Project Name: * Widening of I-440 from Wade Avenue to Walnut Street

Subject: **Request for Modification to the Regional General Permit Number 198200031, Section 401 Water Quality Certification, and Neuse Buffer Authorization for U-2719 – Improve Existing I-440 Beltline, from south of SR 1313 (Walnut Street) to north of SR 1728 (Wade Avenue). Debit WBS 35869.1.2**

Explanation of Permit Impact Site Modifications Being Requested

WETLAND & STREAM IMPACTS
PERMIT MODIFICATION
04/02/2021

PERMIT DRAWING
SHEET 17A OF 48

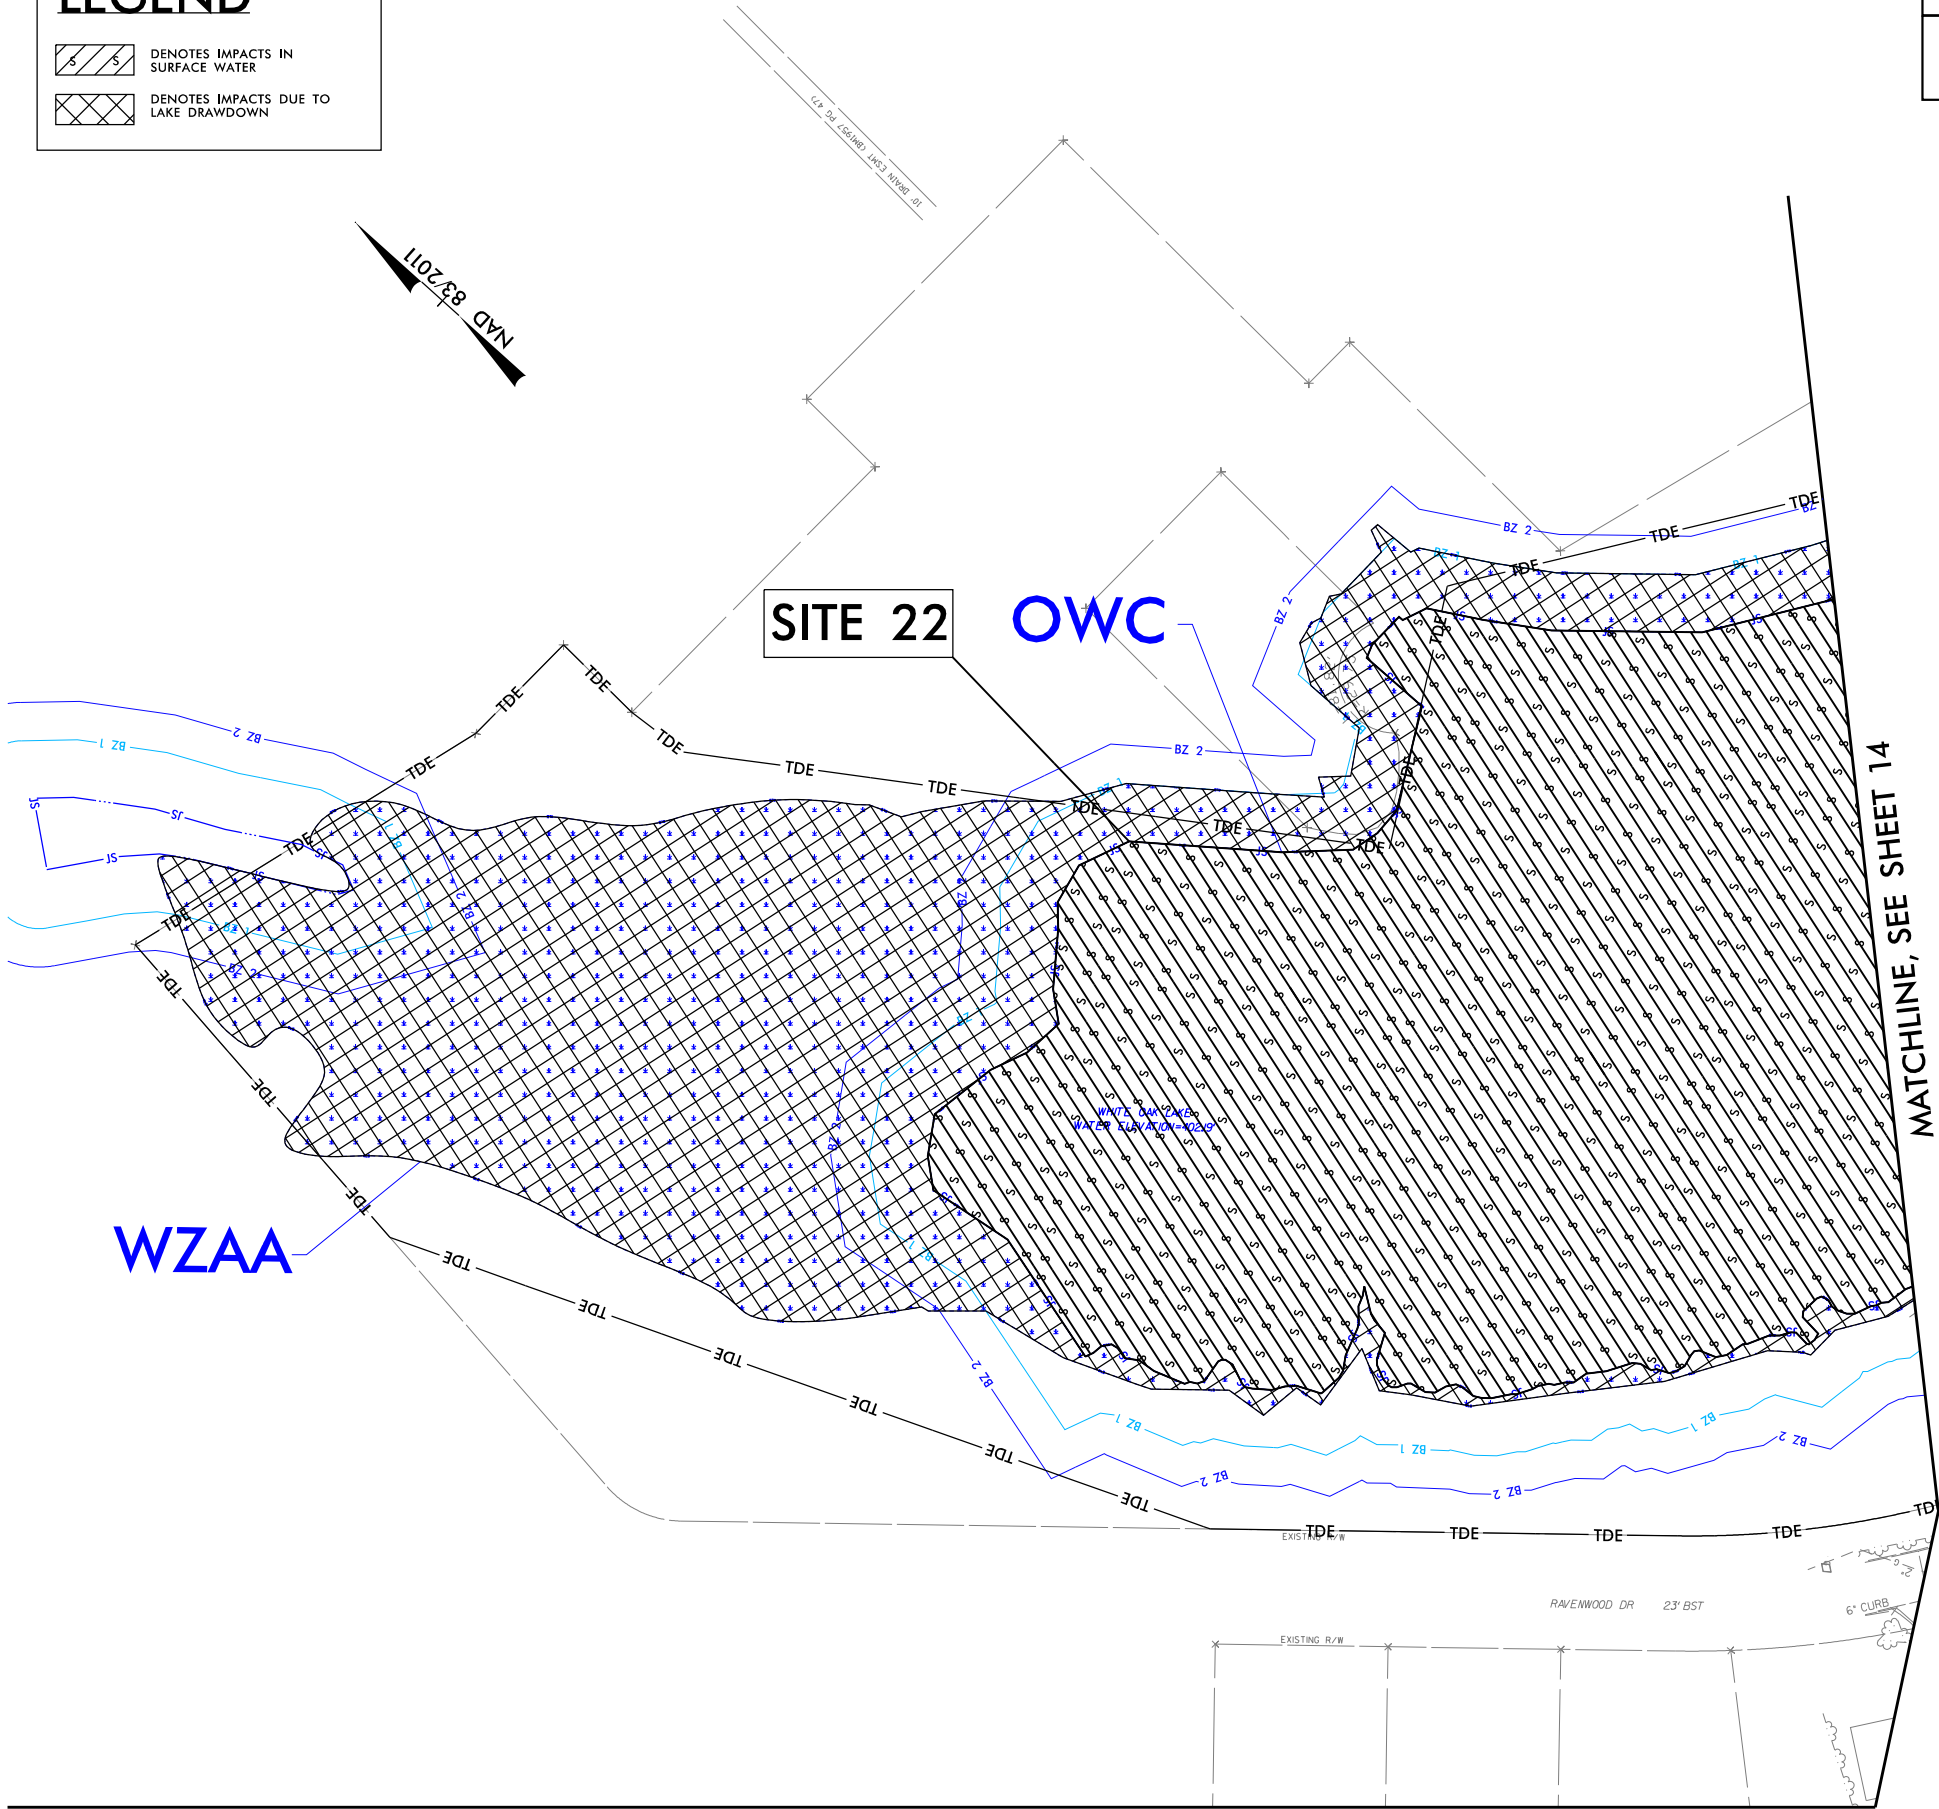
Site 22 (Sheet 14/14A/29A) – Site 22 was added to illustrate the open water impacts associated with breaching the dam of White Oak Lake. The open water impact associated with the breach is 5.10 ac. This site also includes impacts to the fringe wetlands around the lake due to the drawdown of the lake. This area has been hatched on the attached plan sheets and the 2.65 ac of wetland fringe has been noted at the bottom of the summary impact table since it does not match any of the wetland impact types illustrated on the summary table.

**BUFFER DRAWING
SHEET 7 OF 23**

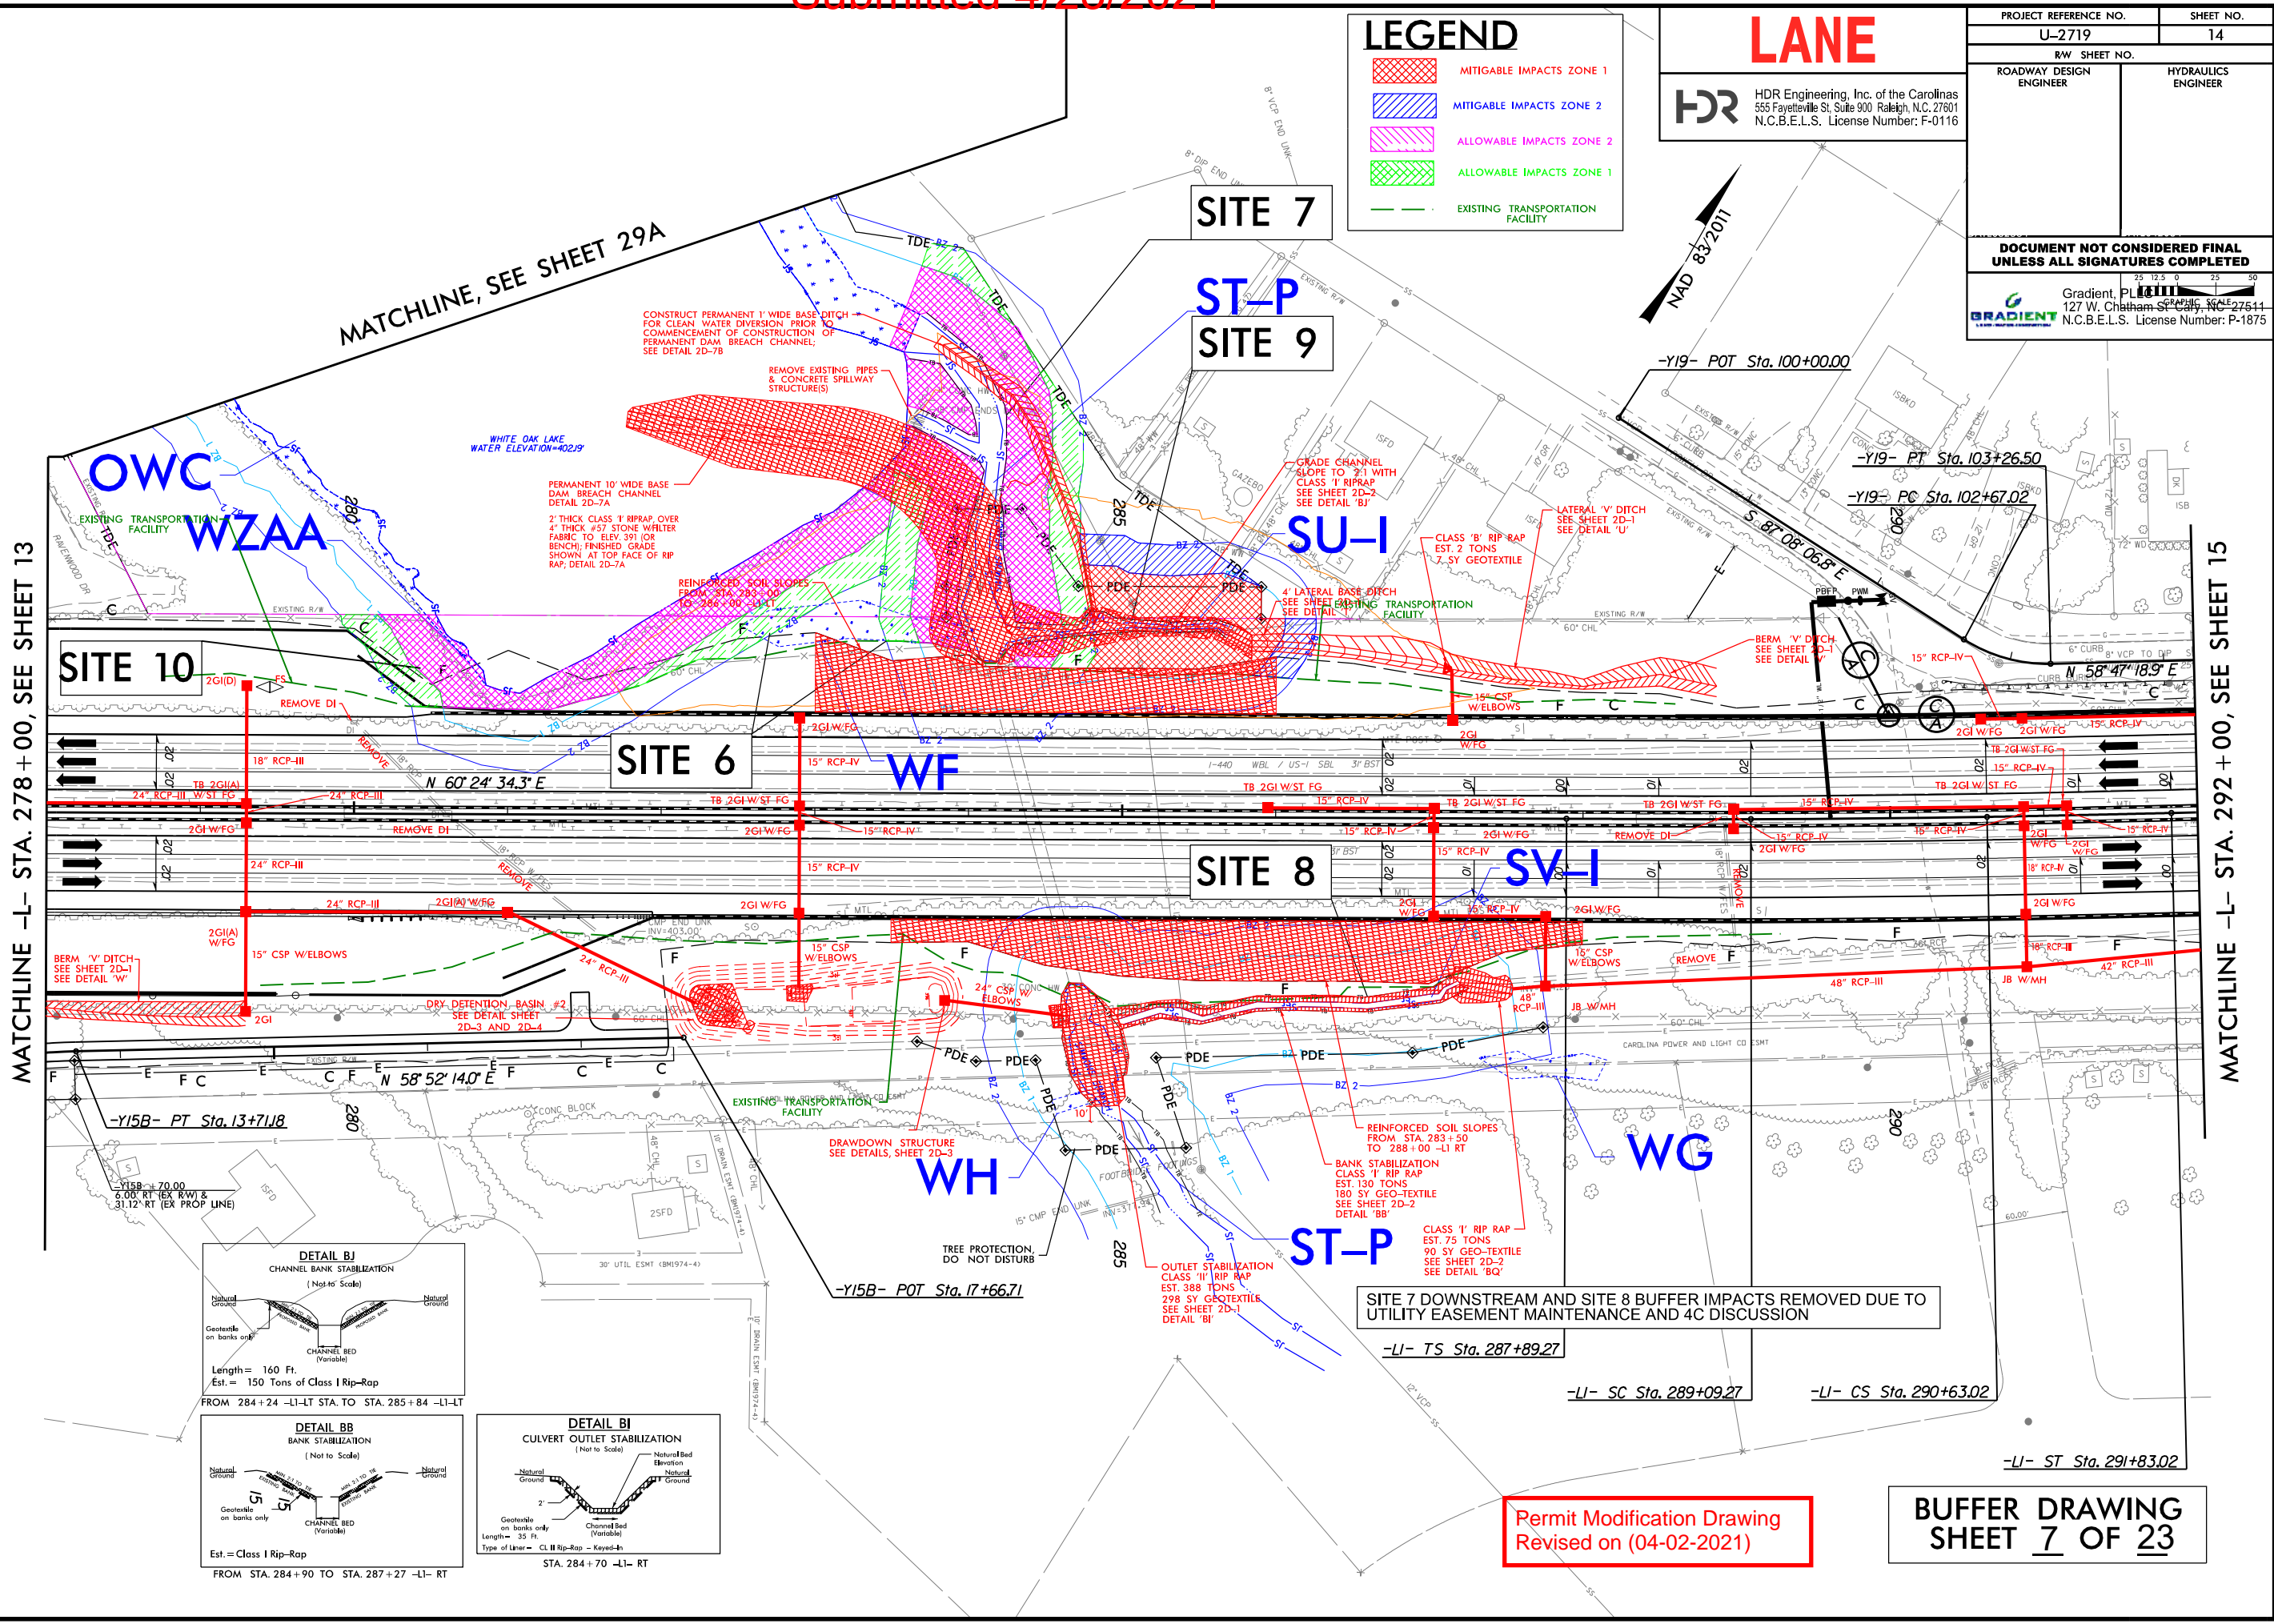
Buffer Site 7 (Sheet 14) – Site 7 buffers have changed as they will now be impacted by the White Oak Lake dam breach and access requirements. The total impact in Zone 1 is 14,399 sq ft and Zone 2 is 6,548 sq ft for Site 7. This is an increase in Zone 1 impact by 12,939 sq ft and 5,677 sq feet in Zone 2. Site 7 buffer impacts on the outlet side were reviewed and it was determined that those have been previously cleared and are no longer illustrated as an impact.

Buffer Site 9 (Sheet 14/14A) – Site 9 buffers have also changed as a result of the new JD file. Site 9 buffer impacts have increased in Zone 1 by 2,708 sq ft to 6,639 sq ft. Zone 2 buffers have increased by 1,392 to 2,738 sq ft. No additional buffer mitigation is proposed for the additional buffers associated with the new JD file, as redesign and impacts are linked to the dam breach impacts which were previously considered non-mitigable by NCDWR.

Buffer Site 10 (Sheet 14/14A) – Previously there were no impacts illustrated with the buffers around White Oak Lake due to the City of Raleigh project. The buffer impacts illustrated at Site 10 are associated with construction and access for the dam breach at White Oak Lake. This results in 10,337 sq feet of Zone 1 impacts and 4,597 sq ft of Zone 2 impacts.
